Permit # City of Portland BUILDING PERMIT APPLICATION Fee

Owner: R.J. Grondin Phone #
Address: LOCATION OF CONSTRUCTION 107 Milton St
Contractor: Custom Built Homes of ME
27 Main St Windham, ME 04062 Phone # 892-3149
Est. Construction Cost: 60,000 Proposed Use: 1-family dwelling
Past Use: vacant lot
of Existing Res. Units # of New Res. Units
Building Dimensions L W Total Sq. Ft.
Stories: # Bedrooms Lot Size:
Is Proposed Use: Seasonal Condominium Conversion
Explain Conversion Minor-Minor Site Plan - Construct 1-fam Dwelling

BUILDING PERMIT REPORT

RE: 107 Milton Street

PLOT PLAN

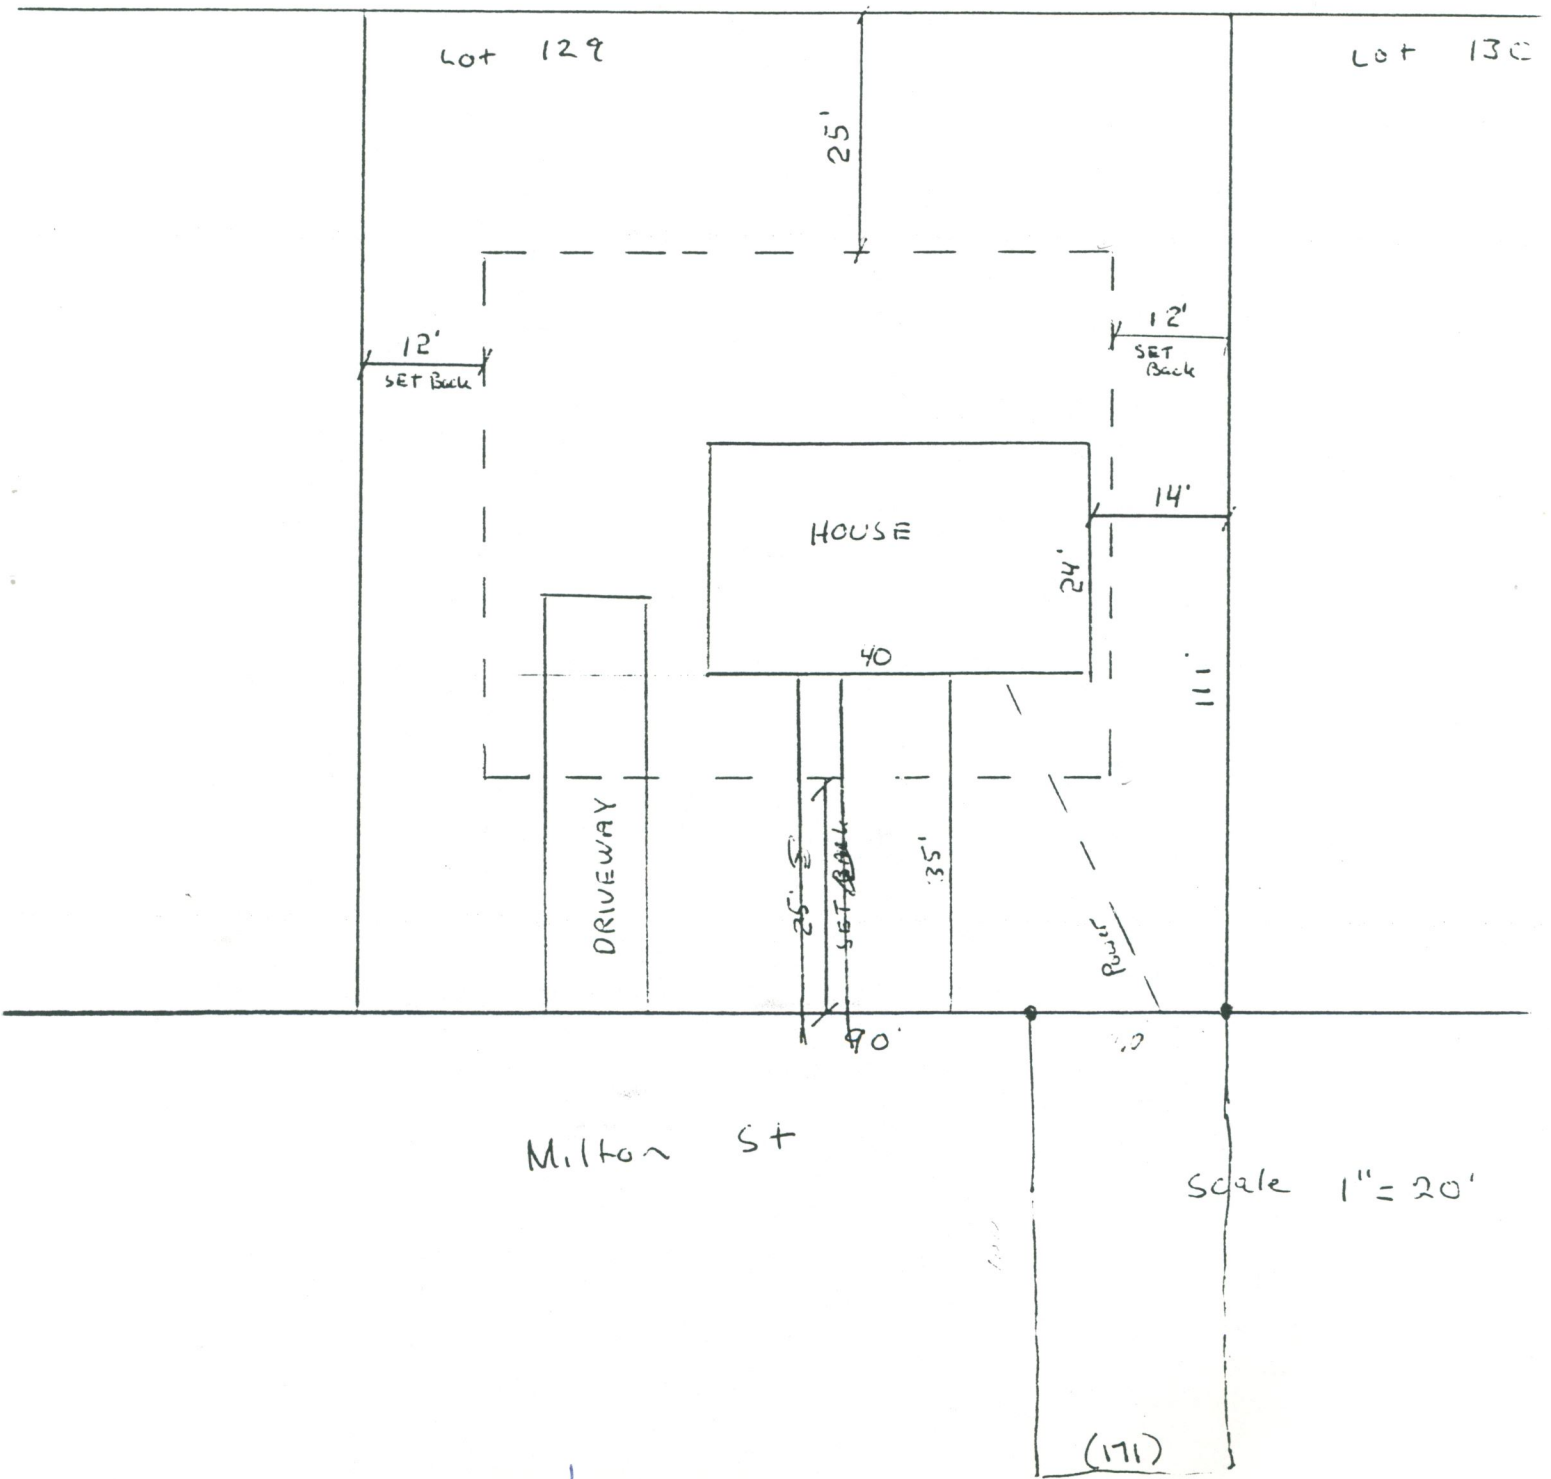
- SET SILL ELEVATION TO ALLOW POSITIVE DRAINAGE AWAY FROM FOUNDATION AND TOWARDS MILTON ST.
